Re: Response to 1st Submission Review - 38th Extension Between Himalaya Rd and Odessa St - Site Plan
Application Number: DA-1127-49
Case Numbers: 2023-6057-00

This letter is in response to the comments received from the City of Aurora dated February 7, 2024. Please see the original comments made below and our response in **bold** following each line item.

38TH AVENUE WIDENING
INFRASTRUCTURE SITE PLAN
TITLE: COVER SHEET

38TH AVENUE WIDENING INFRASTRUCTURE SITE PLAN
TITLE: NOTES & TYPICAL SECTIONS

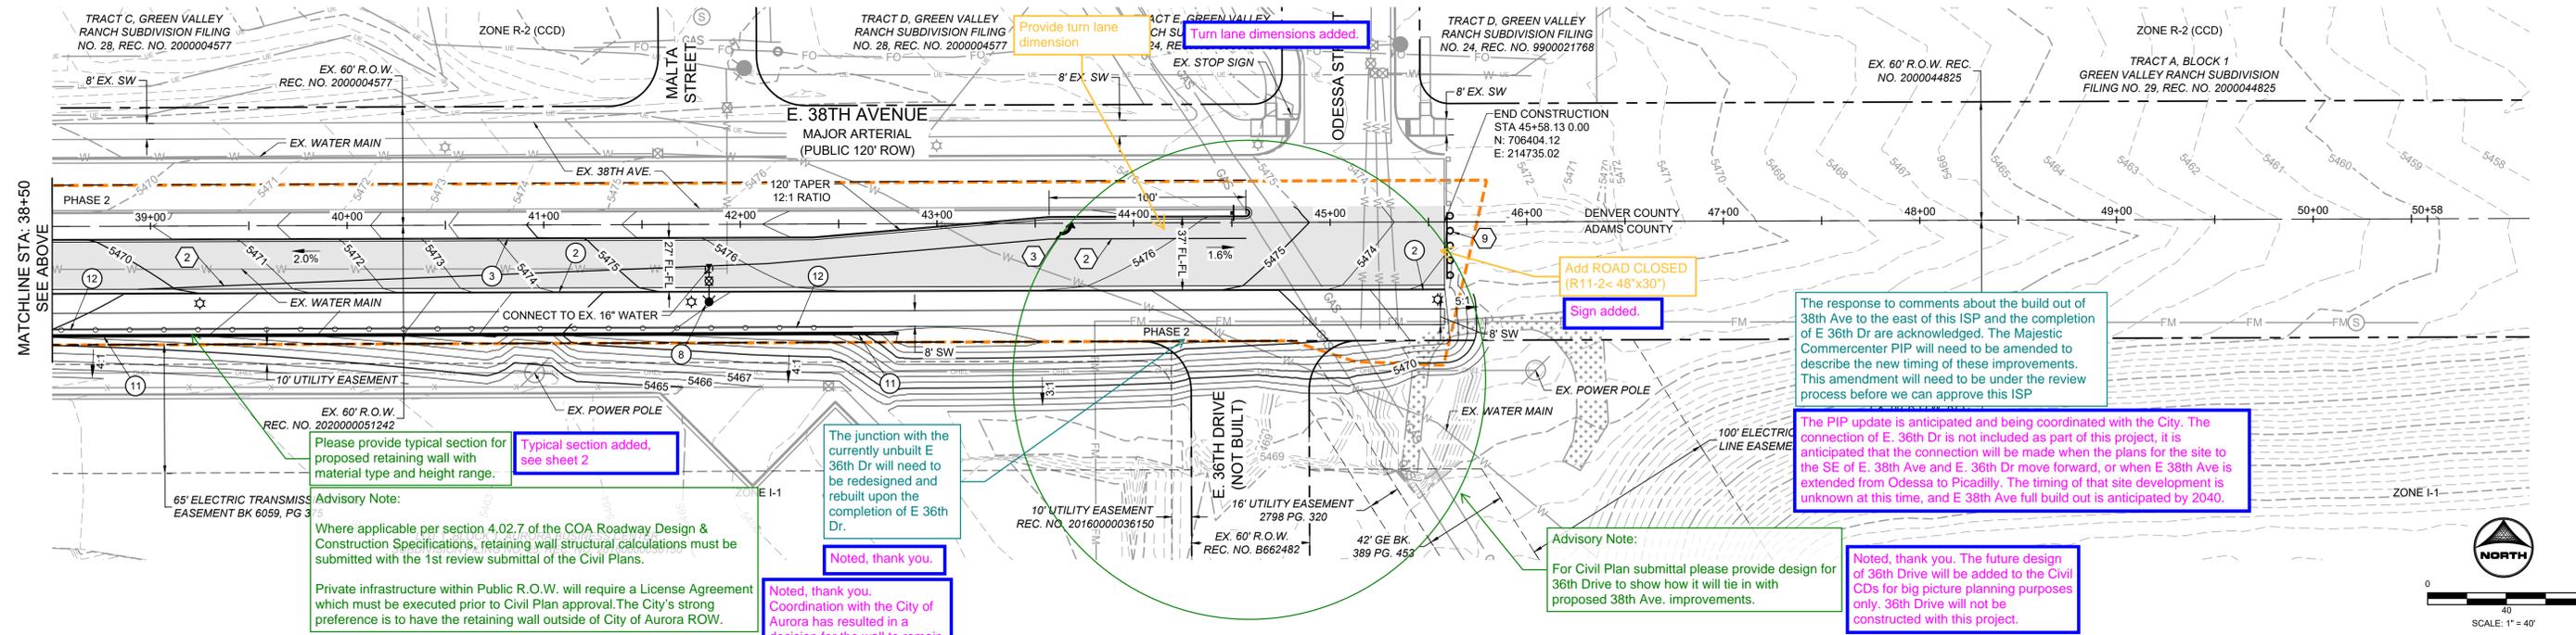
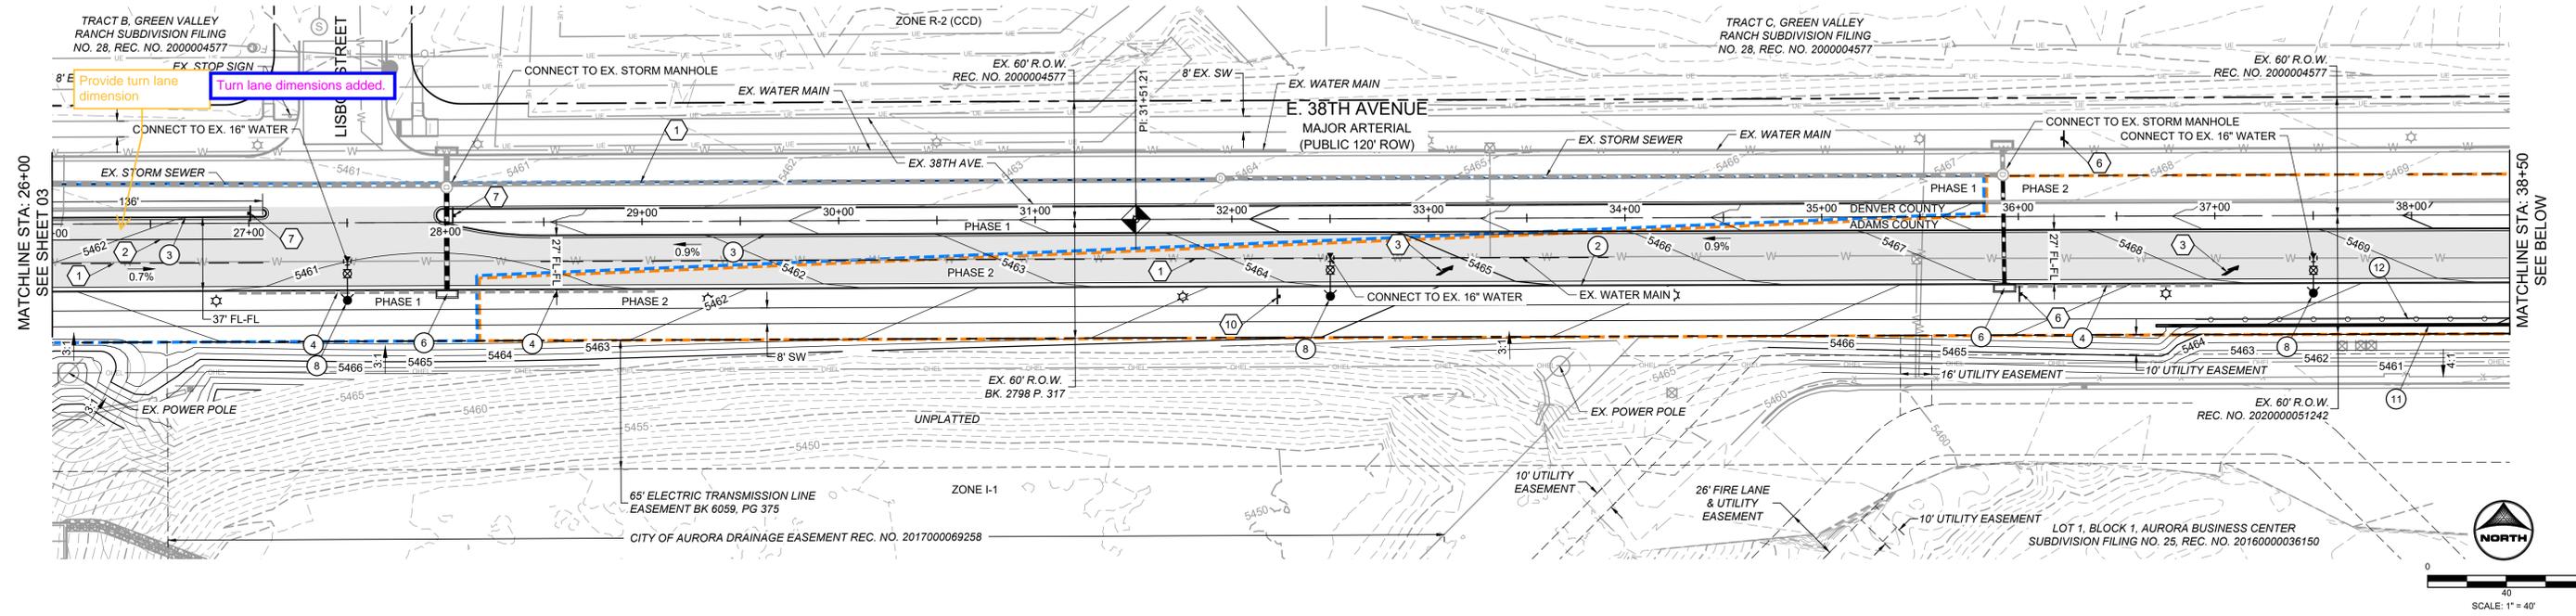
Please provide two-foot recovery zone per section 4.02.8 of the COA Roadway Design & Construction Specifications.

Advisory Note:
Where applicable per section 4.02.7 of the COA Roadway Design & Construction Specifications, retaining wall structural calculations must be submitted with the 1st review submittal of the Civil Plans.
Private infrastructure within Public R.O.W. will require a License Agreement which must be executed prior to Civil Plan approval. The City's strong preference is to have the retaining wall outside of City of Aurora ROW.

The ISP has been updated to include a two-foot recovery zone between the edge of walk and the pedestrian railing.

Noted, thank you. Coordination with the City of Aurora has resulted in a decision for the wall to remain in the R.O.W.

38TH AVENUE WIDENING INFRASTRUCTURE SITE PLAN
TITLE: ROADWAY SITE SHEET

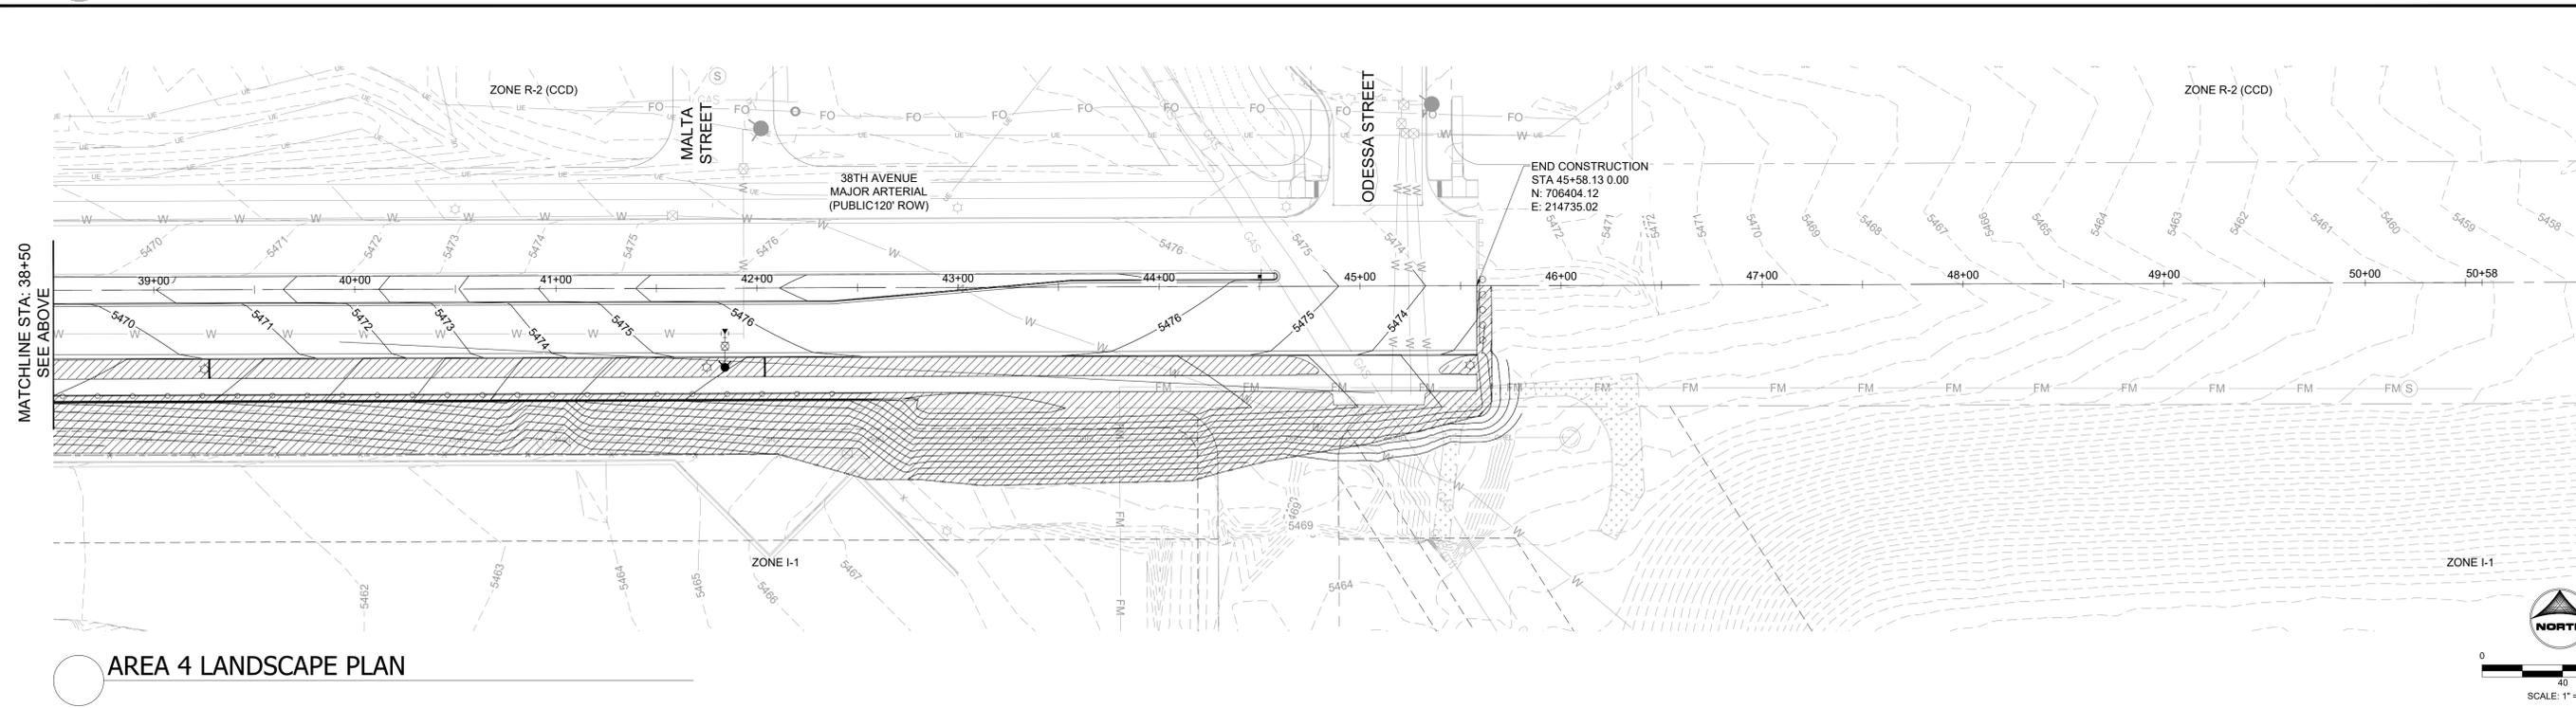
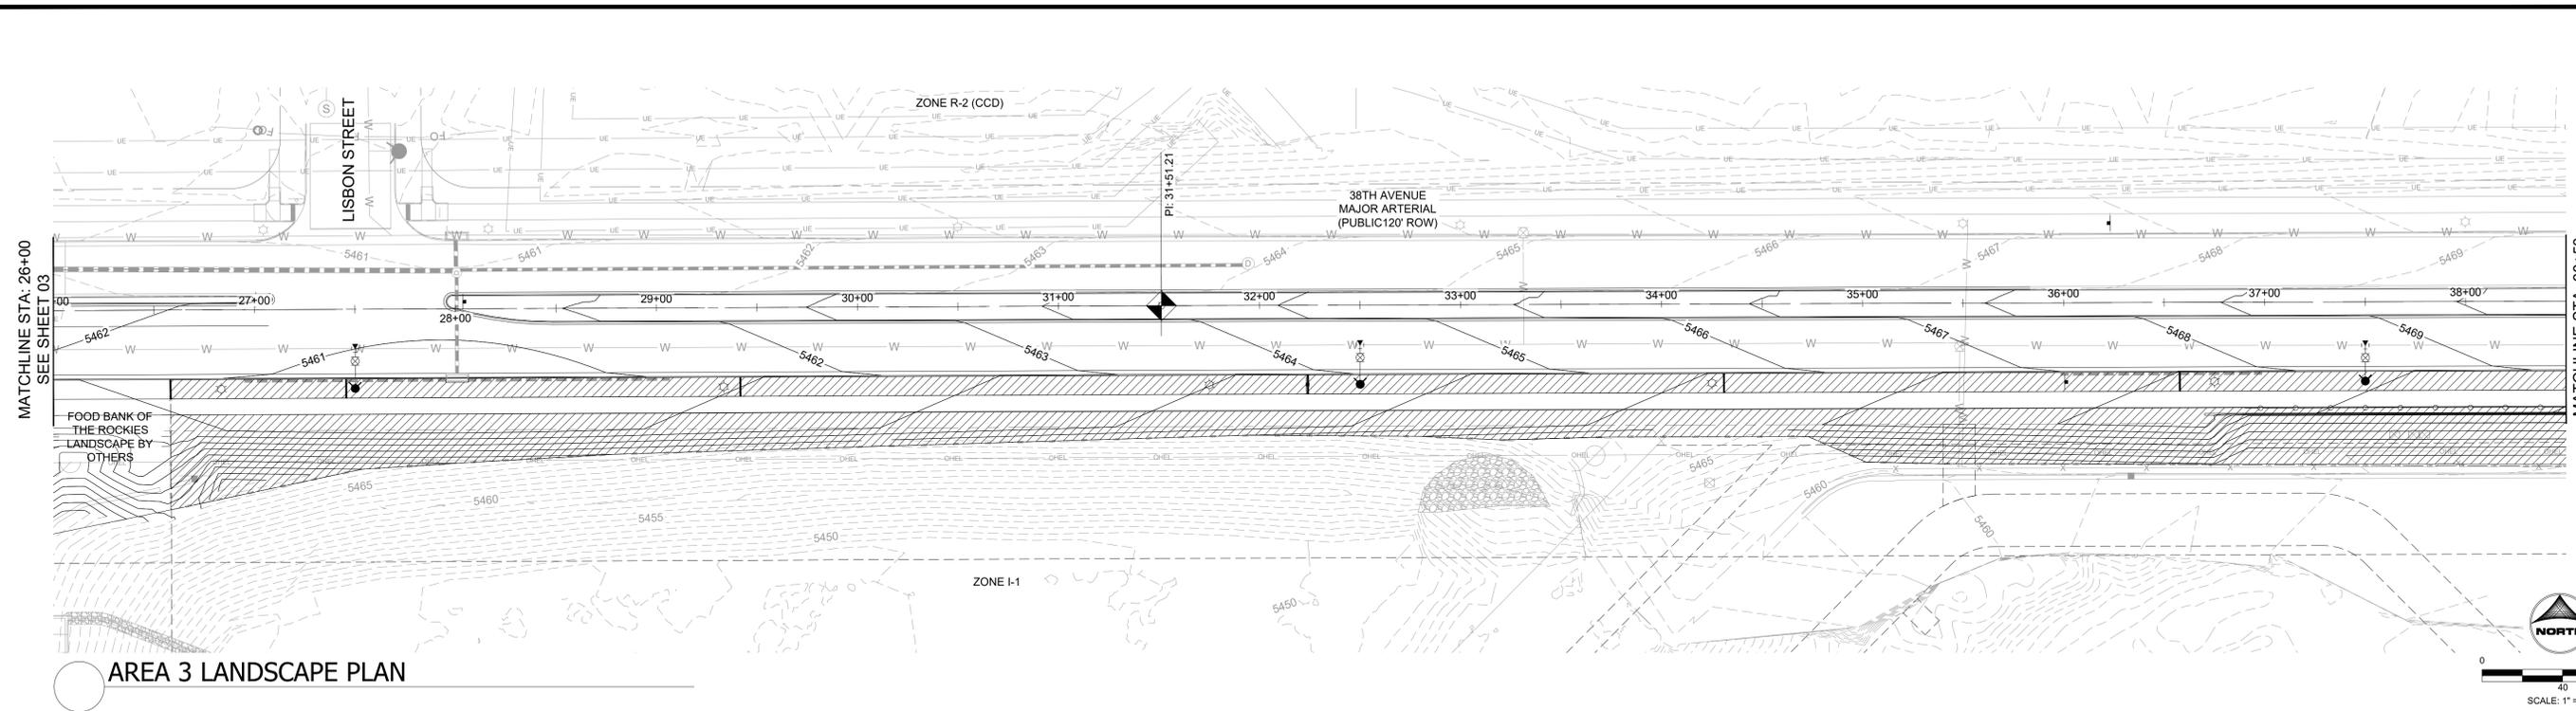
9C. Please provide typical section for proposed retaining wall with material type and height range.

10B. Provide turn lane dimension. [2 comments]

10C. Add ROAD CLOSED (R11-2< 48"x30").

Response: Typical section added.

Response: Turn lane dimensions added.

Response: Sign added.
